From: [Ron Snow](#)
To: [Vanessa Castro](#)
Cc: [DPW_SantaCruzAlameda](#)
Subject: SMCBPAC - Santa Cruz/Alameda Corridor design - serious safety issues - Please require review
Date: Wednesday, February 15, 2023 1:56:29 PM

I am writing to convey my deep disappointment and safety concerns with the proposed 90% design for the "Y" intersection of Santa Cruz and Alameda de las Pulgas. This intersection has a long history of being extremely dangerous and as is well documents through previous communications and meetings.

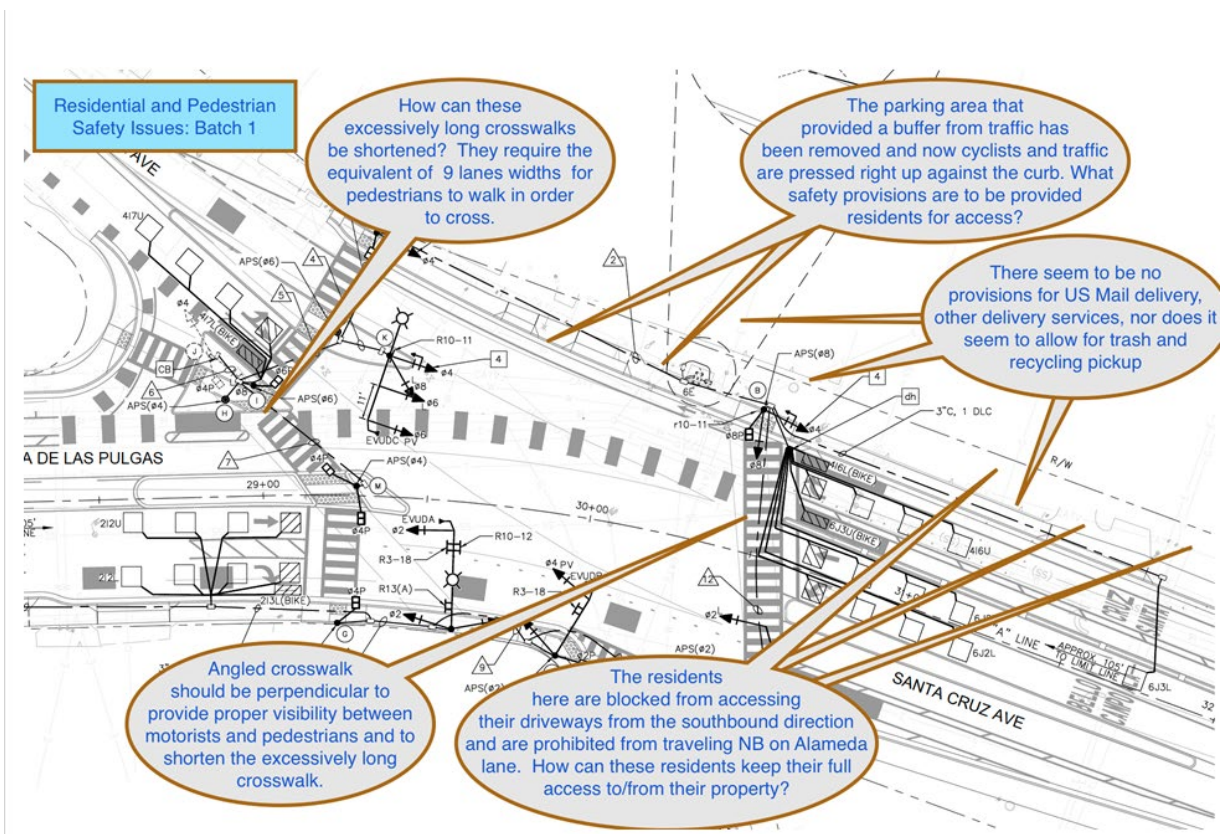
The County 90% design for the "Y" has moved the traffic and cycling paths up against the sidewalk/curb along NB Santa Cruz. We had, with the Y Safety Improvements of 2018, moved traffic away from the sidewalk by as much as 15' to provide a safety buffer. This allowed a much safer sidewalk for pedestrians and provided a safety buffer for residents to access and exit their property. It also effectively shortened that southern crosswalk. This new County plan discards all of those safety gains.

During the Task Force meetings, we asked for many improvements for the Y, including a perpendicular crosswalk on the southern portion crossing Santa Cruz. This was to shorten the crosswalk and correct the visibility problem that the angled sidewalk causes between motorists and pedestrians. In prior versions of the design plan the eastern side had a 7.5' bulb-out on that southern crosswalk to also address traffic - pedestrian separation. This new plan has also scratched that safety feature and created a dangerous situation for all.

- Why aren't the crosswalks lengths reduced to a minimum? These are 250% longer than the road diet at Alameda requires. They are excessively long even crossing Santa Cruz. Guidelines recommend 90° crosswalks for a variety of safety considerations. Why are these crosswalks angled, especially the southern crosswalk?

- Why are the safety of residents not being considered in this new design? This design takes a significant step backwards from a safety perspective by eliminating the buffer between traffic and the properties. Can that be restored and provide safety to/from residential properties?

- Why isn't a slower speed turn being implemented? The slip lane design was designed for 45-50 mph. Why can't this be a curve rated more appropriately for our 25 mph speed? (This would provide the safety buffer for residents and better separation for pedestrians.)

- Residents are being severely limited on access to and from their property. Currently residents have full access to exit and enter their properties from both the north or south directions. The County plan doesn't allow them to access their property from the north. Nor does it allow them to access southbound Santa Cruz, nor northbound Alameda. This seems overly restrictive and unnecessary. There is no mention on what the designer suggests for these residents to mitigate the restrictions of their property..

- Doesn't provide for US Mail or other package delivery trucks
- Doesn't provide for weekly trash and recycling pickups
- The blind corners at Campo Bello and the northern tip of the Y seem still to be an issue. Visibility issues seem to still exist.

- NB traffic should have a stop line that is perpendicular, even if the sidewalk is angled: Again, to safely mitigate the dangerous visibility issue between motorists and pedestrians.

- The design seems to preserve the encouragement of high speed, rather than provide an ambience of 25 mph residential speed.

The Illustration above is from the Y intersection's 90% county plan and identifies a few of the issues identified. This design was originally for an expressway type roadway. With decades of problems, accidents, motorists crashing into homes, confusion, an unacceptable level of accidents, and a high speed feel, we need to step away from that design. We should have a design that is representative of a residential roadway,. A design that feels like a 25 mph speed and through its design elements, delivers that 25 mph and no higher.
